# MM Knit Wear (Extension Buildings)

8 June, 25 August & 6 September 2021

# Observations

Column Layout Plan

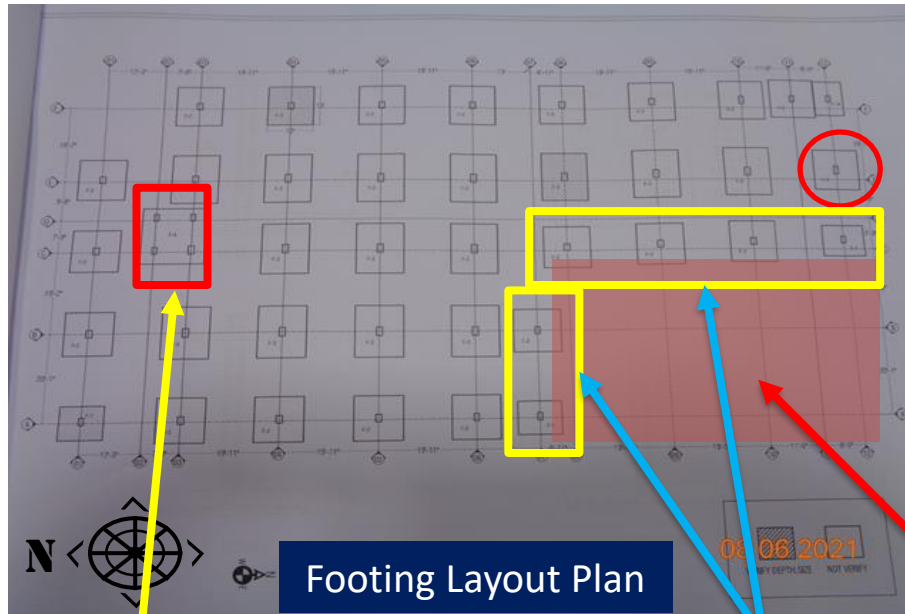
**High stress in column and foundation.**

Cursory calculation indicates that columns are stressed above normal design limit considering observed 2 kPa live load and equivalent concrete strength (11.87 Mpa) based on core test results. Factory engineer is required to review design, load & column stresses of the building.

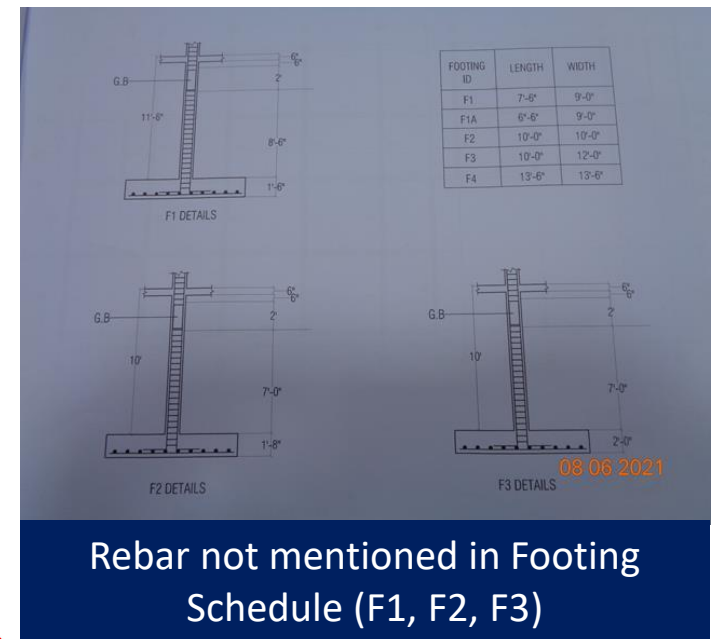
No details of "F4" footing was found in drawing.

Footings may be shared with columns of adjacent buildings (Building 3).

Cursory calculation indicates that footings are stressed above normal design limit considering observed live load (2 kPa), equivalent concrete strength (17.17 MPa) based on core test results and ultimate soil bearing capacity 7.5 ksf (359.1 kN/m<sup>2</sup>). Factory engineer is required to review design, load & footing stresses of the building and suggest remedial actions accordingly.

Rebar Scan Image (C4 column)

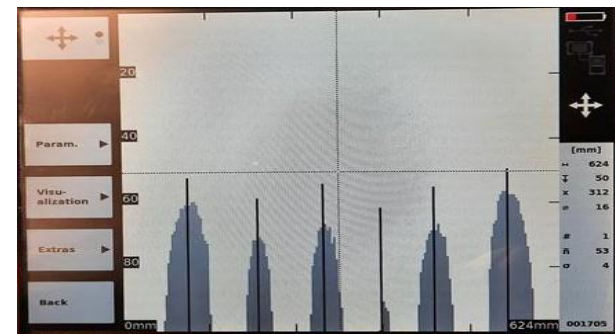
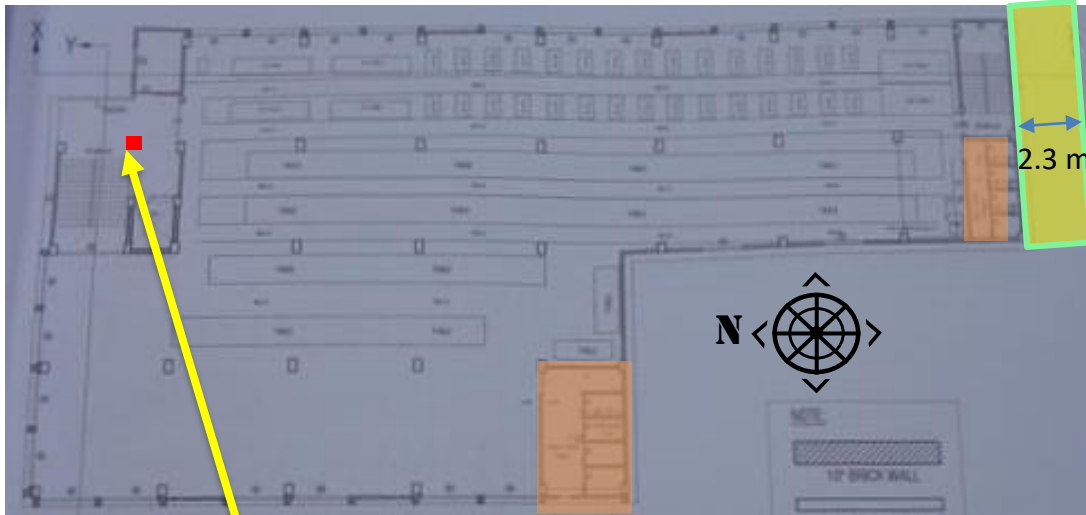
Rebar number of exterior column, (C2 type) was found less than mentioned in column schedule above roof level. On short face, the number of rebar was found 2 instead of 3.

Rebar number of interior column, (C4 type) was found less than mentioned in column schedule. On long face, the number of rebar was found 6 instead of 7.

## Water Ponding on roof

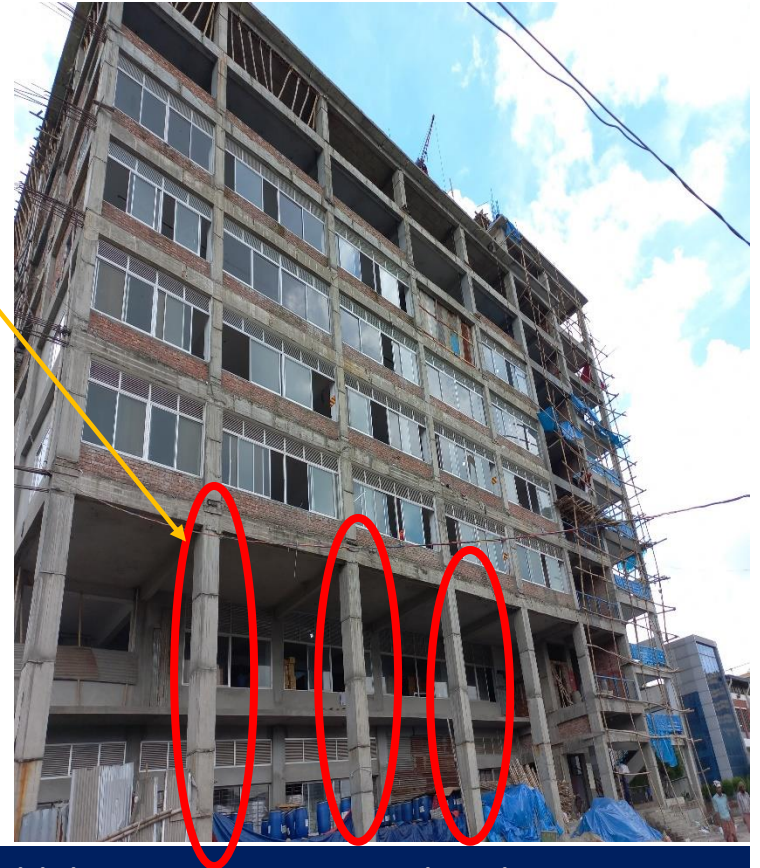
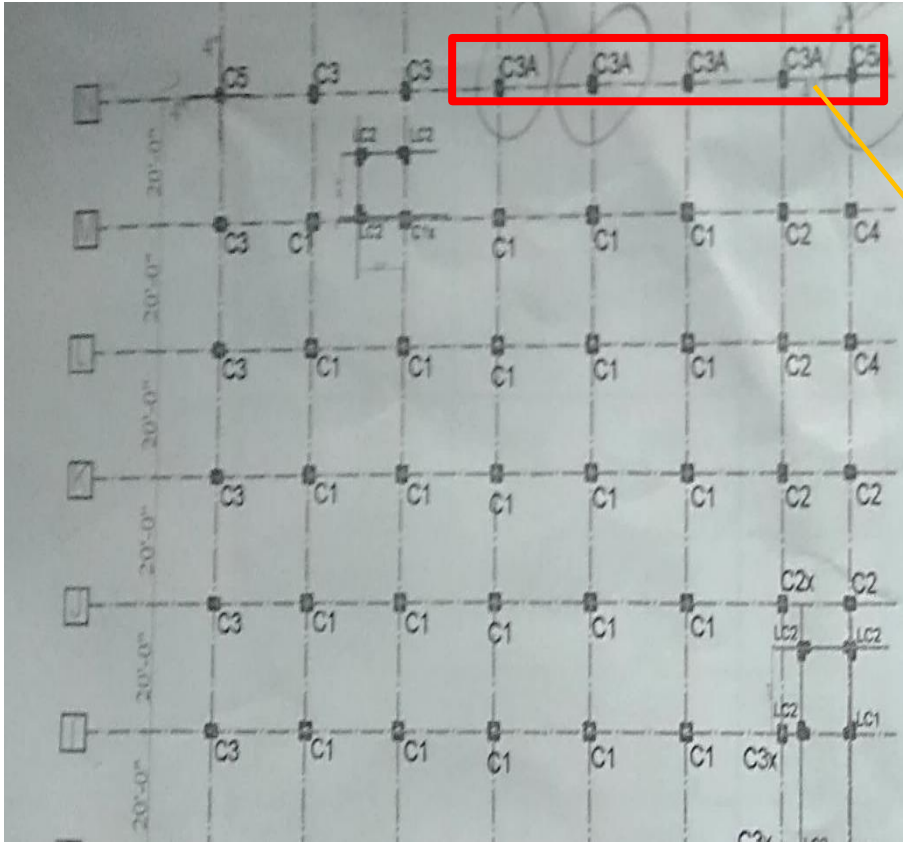
**Water ponding on roof**

Factory is required to develop proper drainage system on roof with adequate slope and apply water proofing compound on roof slab to resist water ingress.

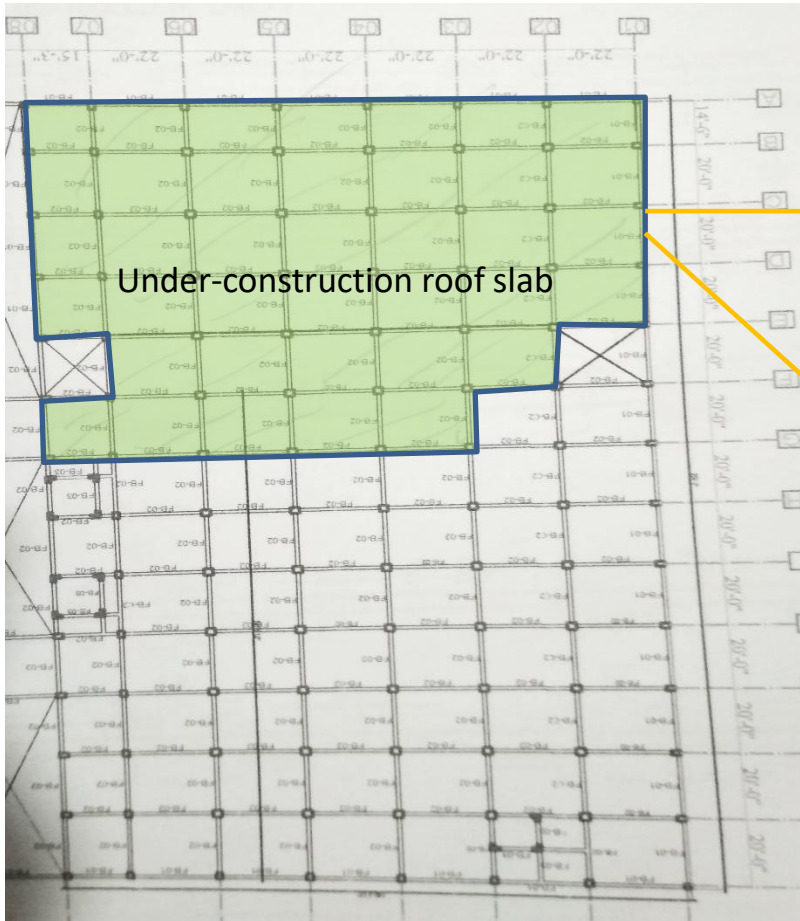
The adequacy check of (C3A and C5A) columns should be incorporate in the design report considering slenderness effects.

Splice of rebar is places in tension zone of beams at several locations. That does not comply with the seismic detailing requirements. The factory engineer is required to check the seismic detailing in the design report.

Uncontrol loading on floor

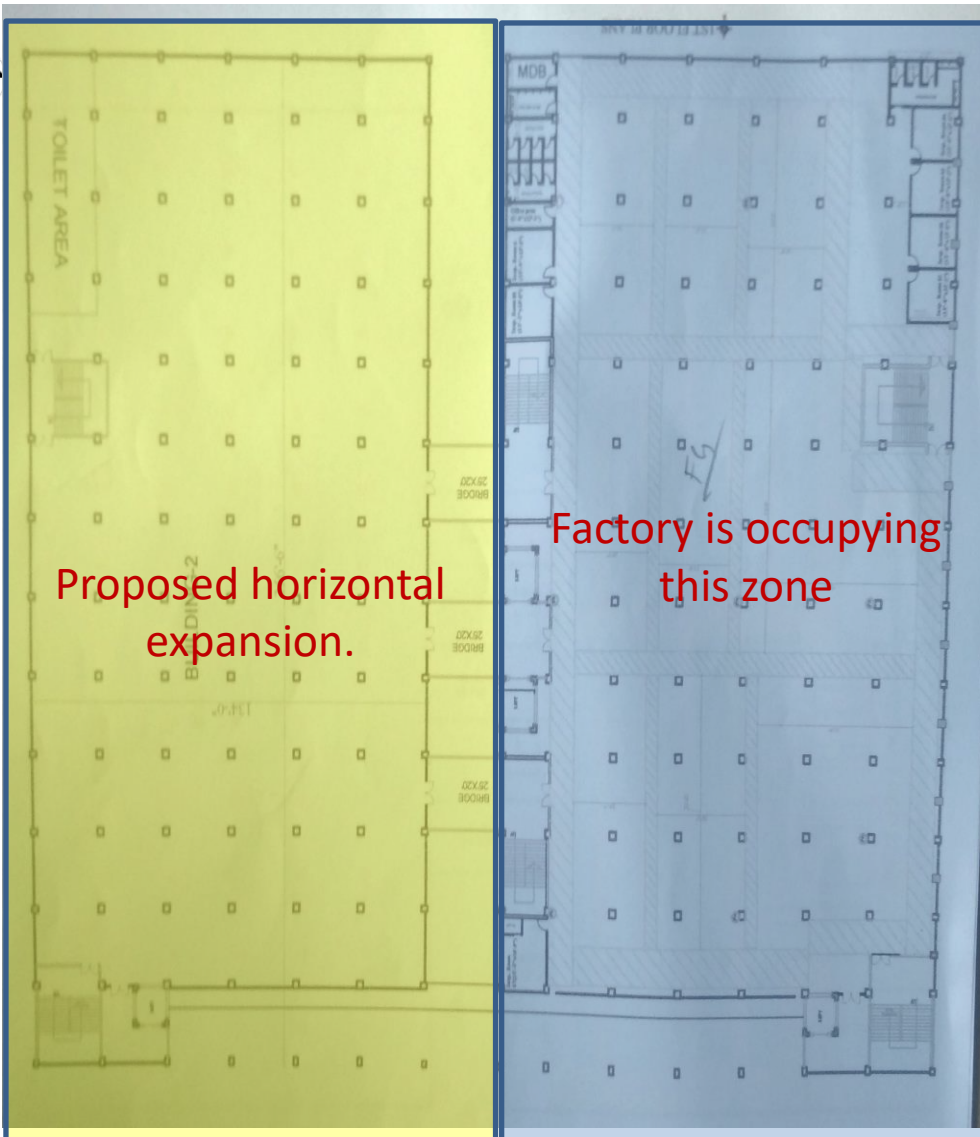
Load plan of the building was not produced. Also, load management program (load plan posting, stack height restriction and signage) was not implemented. Produce and actively manage a loading plan for all floor plates within the factory considering the floor, column and foundation capacity.

## Water ponding on roof

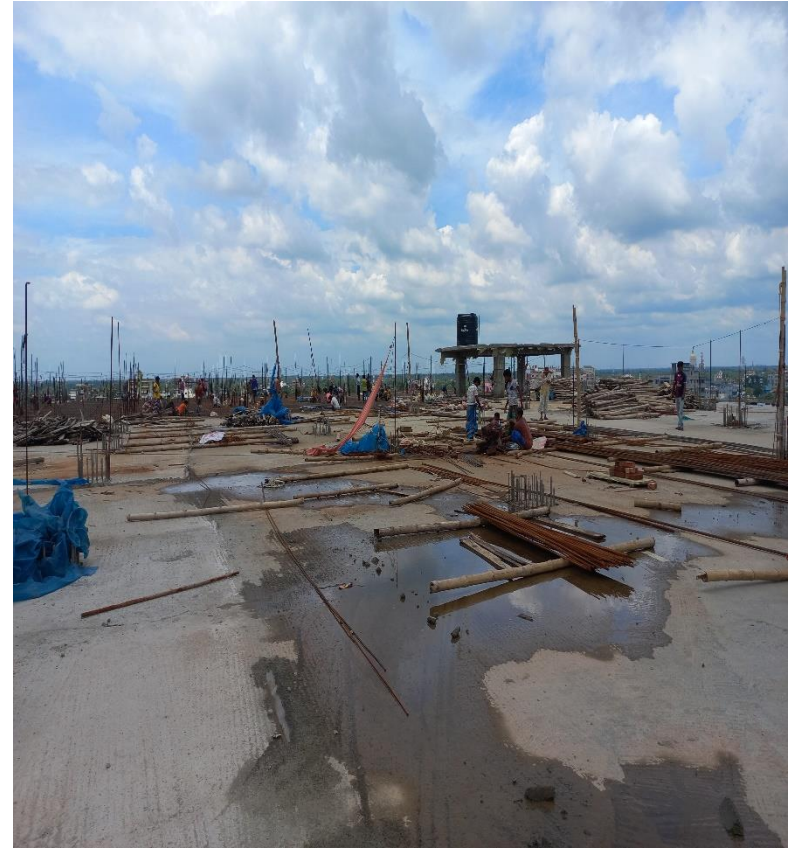
**Water ponding on roof**

Factory is required to develop proper drainage system on roof with adequate slope or apply water proofing compound on roof slab to resist water ingress.

# **Construction debris and exposed rebar**

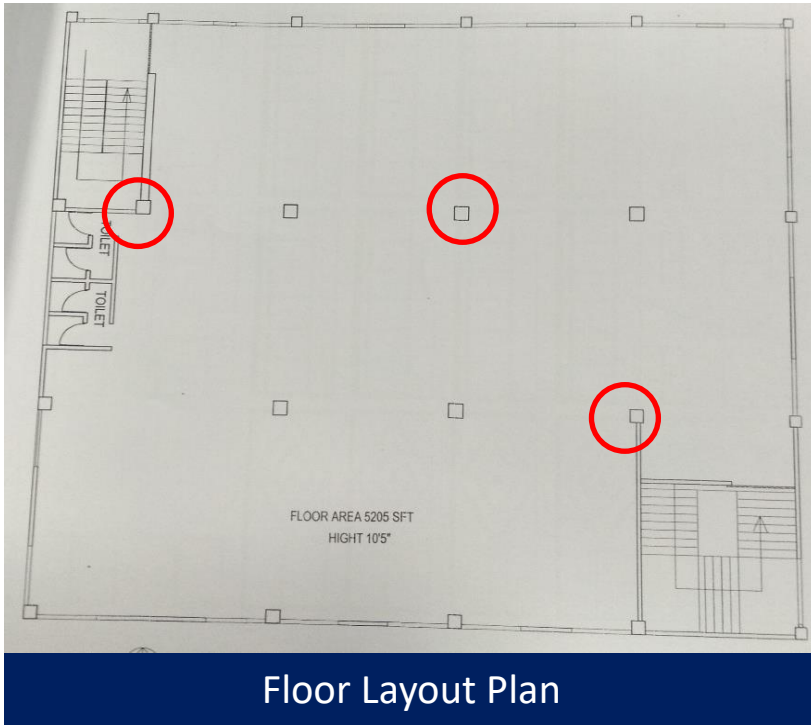
The construction debris at different floor should be removed.

The factory engineer is required to cover the exposed rebar with concrete or apply rust proof paint to protect the rebar from the corrosion.

Floor Layout Plan

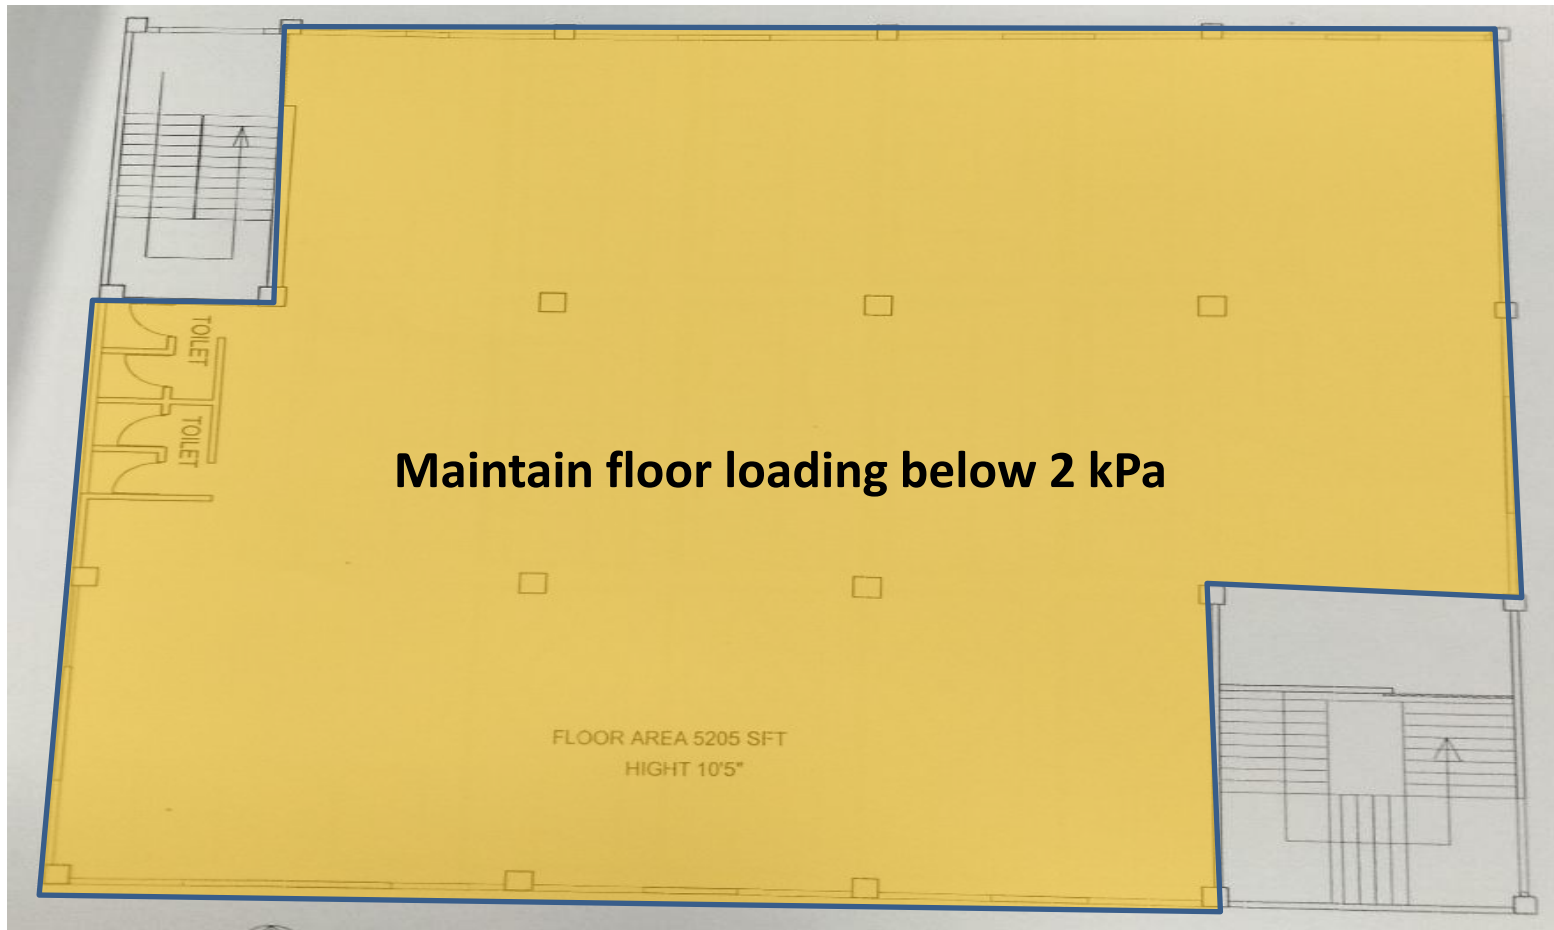
Cursory calculation indicates that columns are stressed above normal design limit considering observed 2 kPa live load. Factory engineer is required to review design, load & column stress.

No geotechnical report was available. Factory engineer is required to prepare a geotechnical investigation report and check the foundation adequacy.

The floor live load at marked zone at all floor level must not exceed 2 kPa until a Details Engineering Assessment is completed.

Steel stair

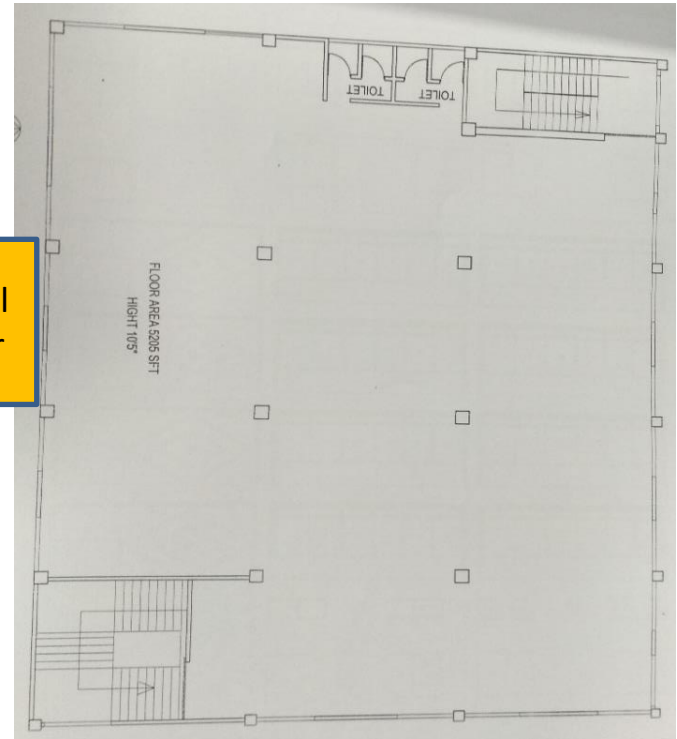
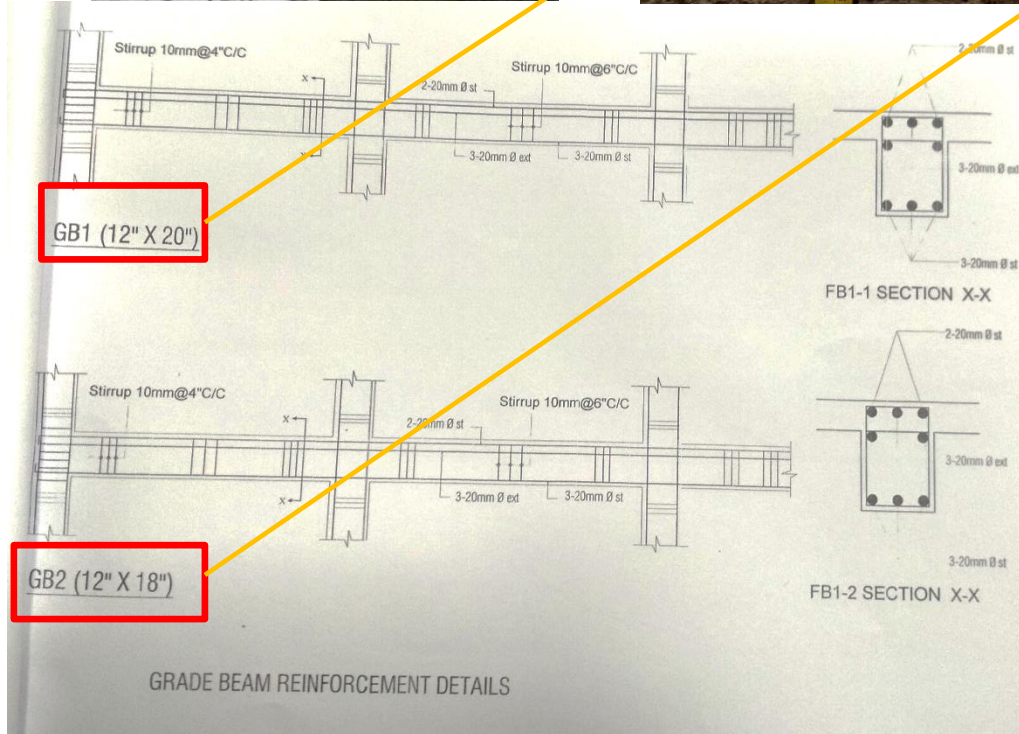
An undocumented steel stair was found at 6<sup>th</sup> Floor of building-6. This structure bridged the Building-2 and Building-6.

Factory engineer is required to up prepare update as built drawing for this structures. Also, incorporate adequacy check for these parts against lateral load.

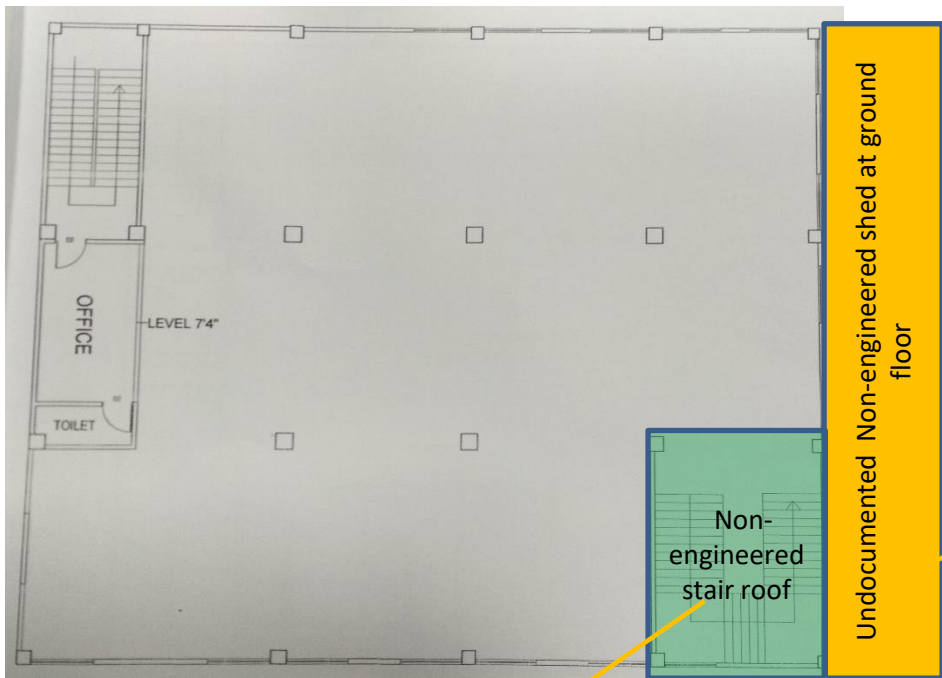
The size of grade beam GB-1 and GB-2 were mentioned 12"X20" and 12"X18". But at site the depth of GB-1 and GB-2 were found 16" and 14" respectively instead of 20" and 18".

## Water ponding on roof

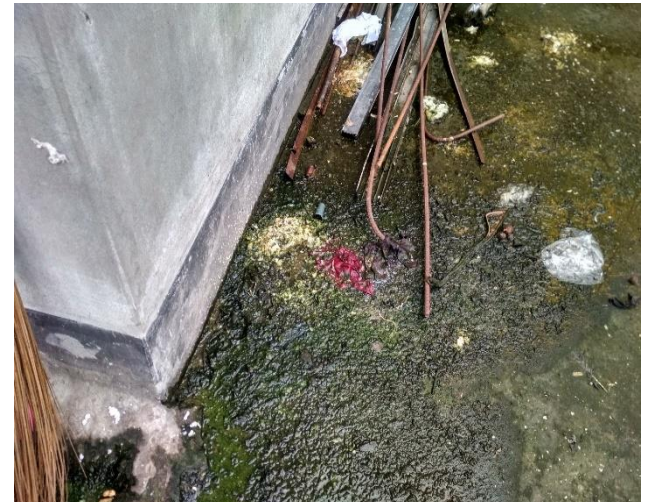
Stagnant of water

Factory is required to water proofing compound and develop proper drainage system on roof with adequate slope to resist water ingress to slab.

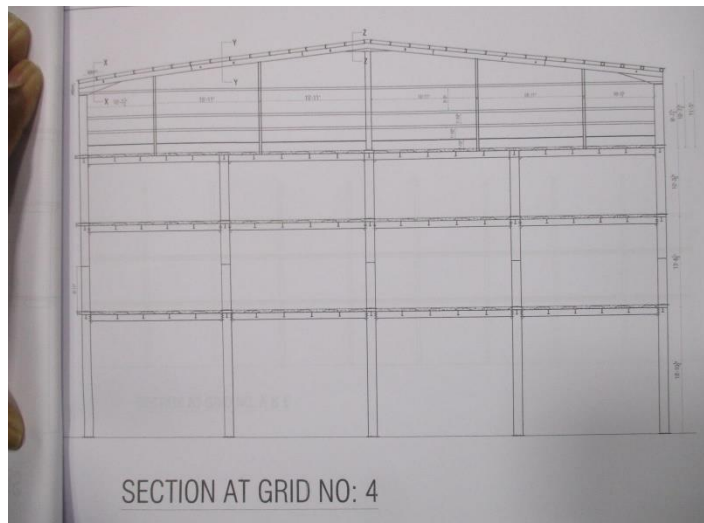
350 mm built-ups at rooftop toilet zone

225 mm built-ups at rooftop wash zone

At open area of the roof, undocumented toilet zone & wash space with floor built-ups and pump room with lightweight steel shed was observed.
